Tram, Granton to Bioquarter consultation

Spokes Planning Group response, November 2025

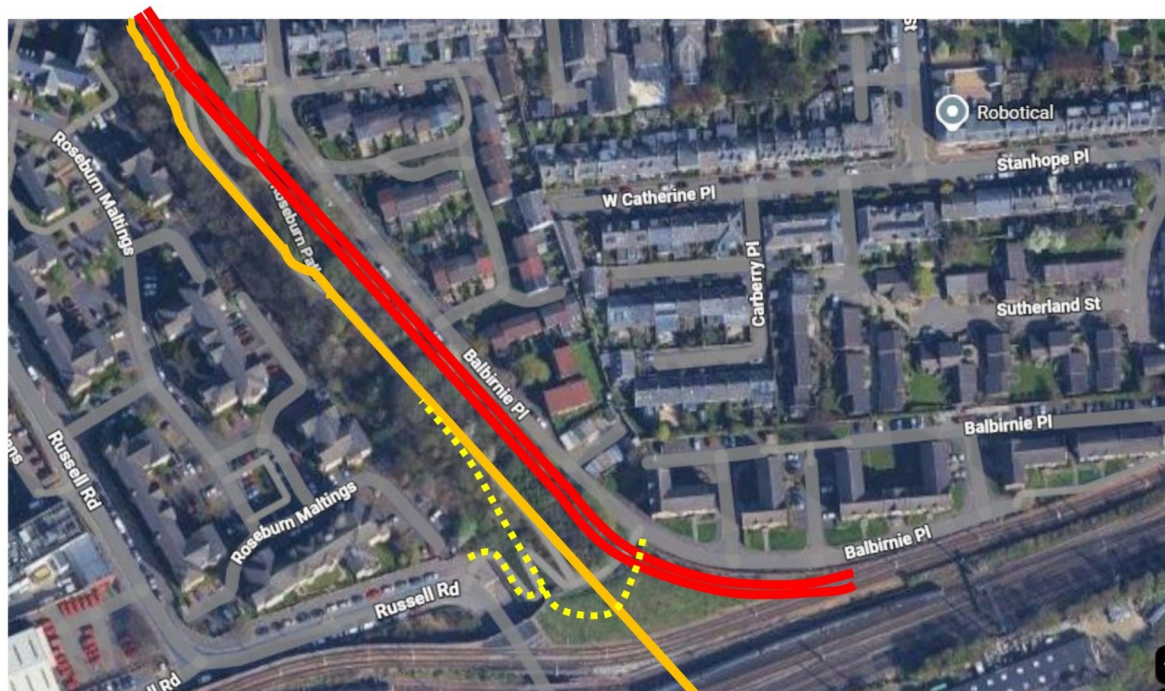
- **North of Roseburn** - the Council is to be congratulated on modifying the project north of Roseburn bridge to single track, and with battery running, enabling a 3m+ active travel path (with one identified pinch point at Telford Road – see below). This follows the instruction to the tram team by councillors at the 1.2.24 Transport [Committee](#) for which we again thank all members and others who contacted councillors at that time. If at the detailed design stage there are problems with achieving the full 3m at any point, measures such as moving the tramway slightly laterally, or modifying embankment or cutting heights should be employed to ensure the full 3m.

- South of Roseburn** - the connection from Roseburn to the superb new path to the Canal lacks clarity, and indeed there are contradictions in the consultation materials – see [these clarifications](#) from the tram team, the [Roseburn bridge cross section](#), the [path cross section](#), the [artist impression](#) and the [map view](#). Furthermore, some of these materials talk of 2m width, which is clearly substandard. We appreciate that there are engineering challenges here, but challenges are there to be met. Secondly, the consultation does not mention the massive opportunity to implement the Mobility Plan project [[Mobility Plan, Active Travel Delivery](#) , page 43] to connect the two paths with a **bridge over the existing tramway and mainline railway**, meaning no need to descend to road level and up again. Both these issues would raise costs but would be a minor element of total project costs, the benefits to active travel of the level connection would be transformative, and not to include the bridge if the tram uses Roseburn would render it unlikely for the foreseeable future. In summary, the Council must seek to include this connection between the two routes, with the requisite engineering studies and costings before the next consultation. Ideally the connection would be the 4m width of the new Canal link, but certainly no less than 3m, and with no pinch points. See bullet points below for detailed suggestions.

Illustration of conceptual one-way tram routes for consideration - Spokes

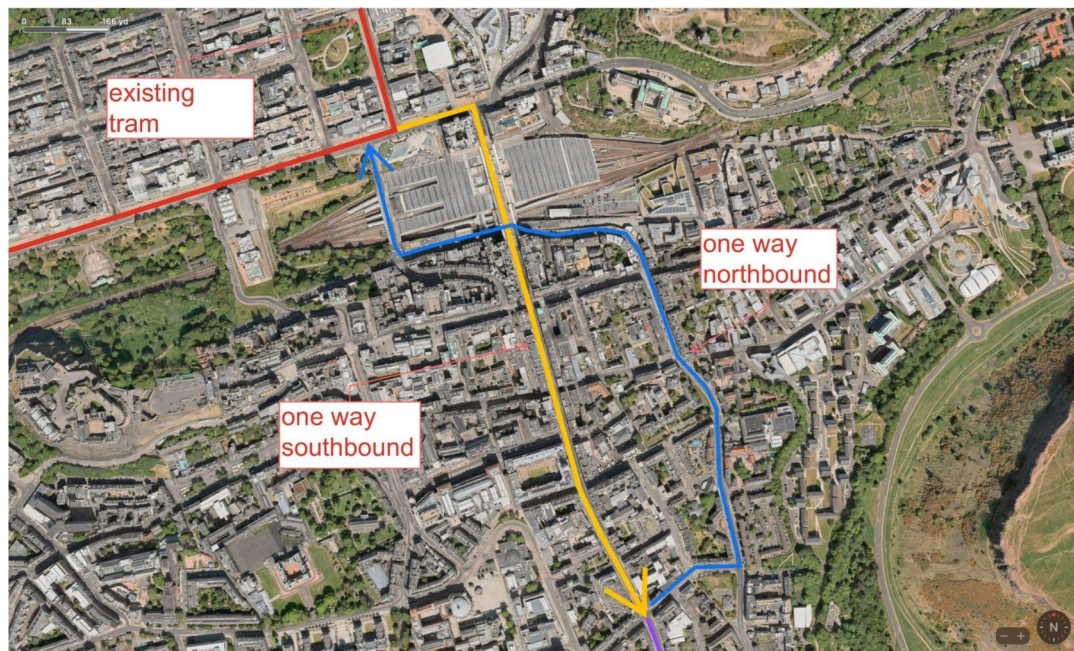
- There is an alternative routing in Edinburgh which Spokes suggests for investigation for northbound trams, if not already considered; this is via Market St / Jeffrey St / Pleasance. The gradient of Pleasance has been flagged as too steep however Orchard Brae is steep and is being proposed. Also trams in Sheffield already run at a 10% gradient so this option should be reassessed.

This option would come with pros and cons relative to a short single track section of bidirectional operation so would need to be carefully considered. However, it would better serve Waverley (nearer platform level) as well as the Cowgate and Dumbiedykes of which the former has no improvement in connectivity in the current proposals. Very importantly, from Spokes perspective, it would free up street space for high quality active travel provision.
